SERVICE ADVISORY # 08- 100**Fuzion Propane Line Replacement**

Models Included: 2007 – 2008 Fuzion 373 Fifth Wheel

Fig. 3

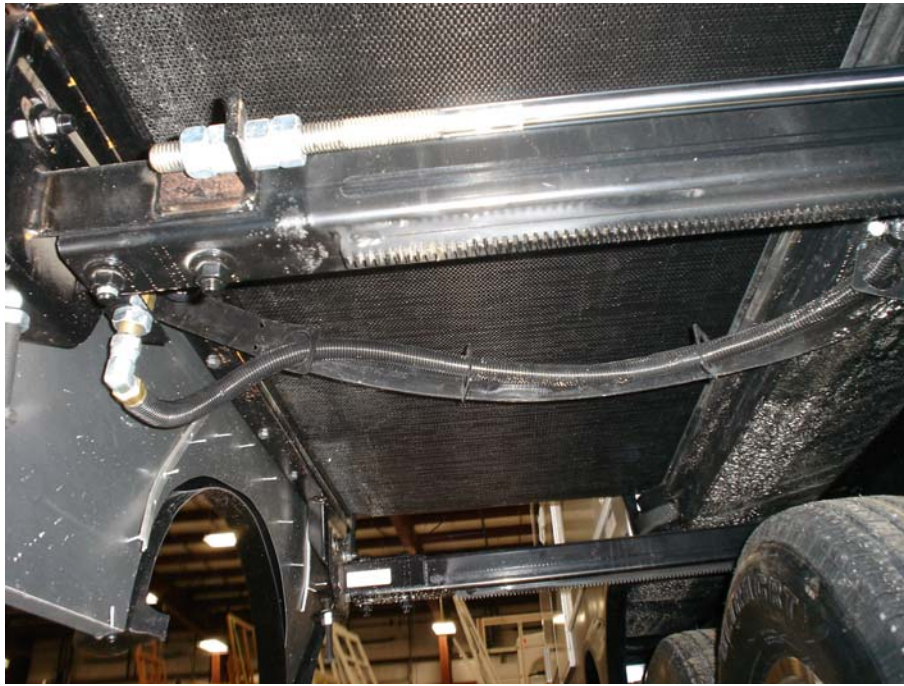
Keystone RV Company is conducting a voluntary RECALL notification campaign in accordance with the National Traffic and Motor Vehicle Safety Act. The vehicles subject to this recall campaign have been manufactured with excess length in the propane hose for the slide room allowing the hose to droop too close to the tire. The propane line may become damaged as a result of contact with the tire. A propane leak, in the presence of an ignition source, could result in a fire and/or explosion causing property damage and/or personal injury.

- Step 1.** Install new 68 3/8" LP hose in flex guard assembly.
- Step 2.** Install flex hose on LP manifold on slide out room.
- Step 3.** Install flex hose on main LP manifold.
- Step 4.** Reposition the flex guard to remove any play between flex guard and the LP hose. See figure 3. Cut off excess flex guard. Refasten the flex guard to the LP mounting bracket on the kitchen slide out.

- Step 5.** Run the room to the in (travel) position. Verify there is now 3" clearance between the tire and the propane hose flex guard when the suspension is at rest position. The unit must be parked on a flat surface and level.
- Step 6.** Perform a LP Drop Pressure Test.
- Step 7.** Turn the propane on at the LP bottles. Check the LP connections for leaks with a commercial leak test solution.
- Step 8.** Reconnect the 110v and 12v power.
